8. Well Name and No.  
HUSKY - MCKAY 19. API Well No.  
30-005-6161610. Field and Pool or Exploratory Area  
ABO11. County or Parish, State  
CHAVEZ COUNTY, NM**SUBMIT IN TRIPLICATE - Other instructions on page 2**

13. Describe Proposed or Completed Operation: Clearly state all pertinent details, including estimated starting date of any proposed work and approximate duration thereof. If the proposal is to deepen directionally or recompleat horizontally, give subsurface locations and measured and true vertical depths of all pertinent markers and zones. Attach the Bond under which the work will be performed or provide the Bond No. on file with BLM/BIA. Required subsequent reports must be filed within 30 days following completion of the involved operations. If the operation results in a multiple completion or recompletion in a new interval, a Form 3160-4 must be filed once testing has been completed. Final Abandonment Notices must be filed only after all requirements, including reclamation, have been completed and the operator has determined that the site is ready for final inspection.

**Husky-Mckay Federal 1  
30-005-61616  
Marathon Oil Permian LLC  
July 23, 2018  
Conditions of

**Husky-McKay 1**

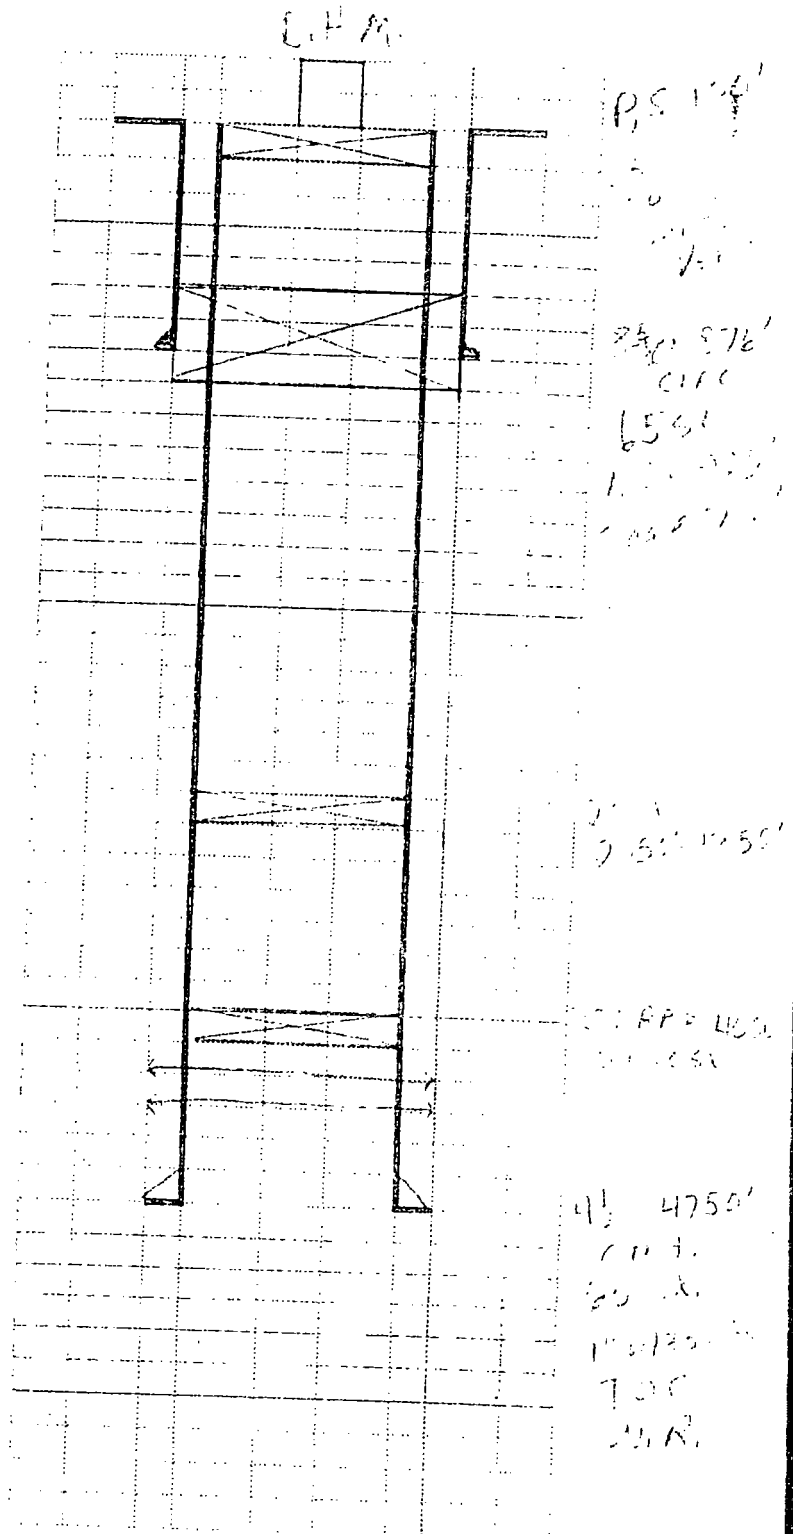
- 1. Operator shall place CIBP at 3,986' (50'-100' above top most perf) and place 120sx Class C cement on top as proposed. WOC and TAG.**
- 2. Operator shall place a balanced Class C cement plug from 2,000'-1,800' to seal the top of the Glorietta Formation.**
- 3. Operator shall place a balanced Class C cement plug from 926'-700' to seal the shoe.**
- 4. Operator shall place a balanced Class C cement at 100' bringing cement to surface.**
- 5. See Attached for general plugging stipulations.**
